Technical Service Bulletin: TSB140012

Released Date: 12-Feb-2014

QSK19 Industrial Cast Iron Gear Cover

Figure 1

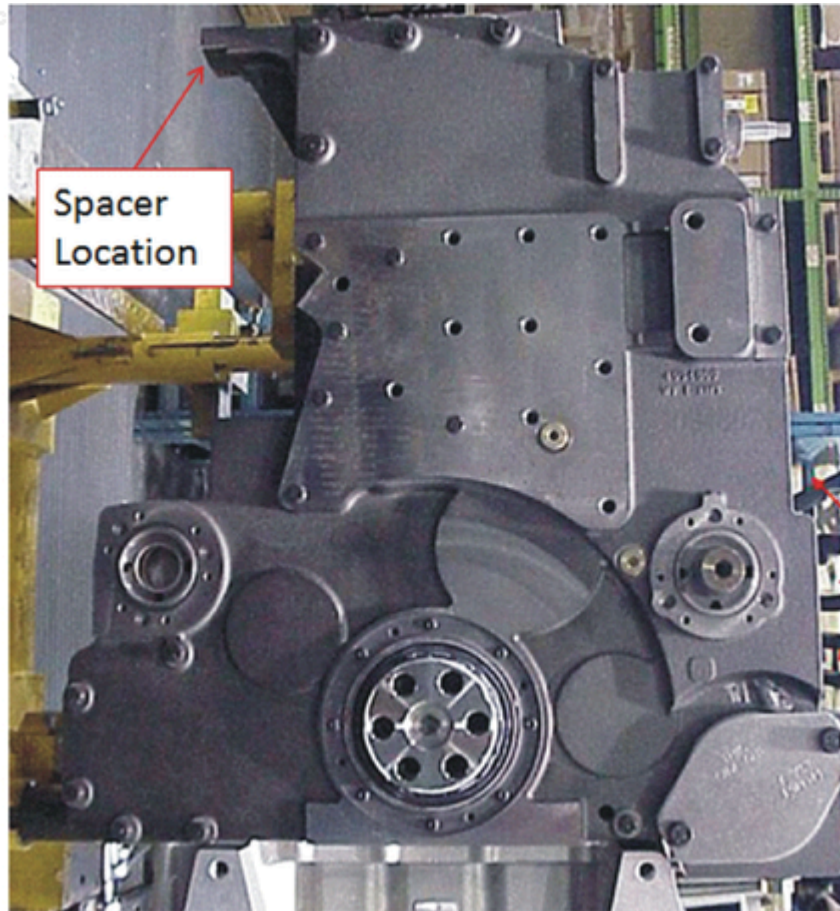
This document introduces a new front gear cover for the QSK19 Industrial engine.

The new gear cover, Part Number 4333889, is only available for service replacement. The old gear cover, Part Number 3090327, is still available for production.

The new gear cover is made from cast iron and provides a more robust mounting surface at the accessory drive than the previous aluminum gear cover. Applications that do not meet the requirements in AEB 21.37 must use this cast iron gear cover. Contact an Authorized Cummins® Distributor for access to this Application Engineering Bulletin. A spacer, Part Number 4333920, must be used with the cast iron gear cover, in order to mount the thermostat housing (Figure 1). Refer to Procedure 008-015 in Section 8 (</qs3/pubsys2/xml/en/procedures/20/20-008-015-tr.html>) in the QSK19 Industrial Service Manual, Bulletin 4021592, for installation instructions. All capscrew torques remain unchanged for the new cast iron cover.
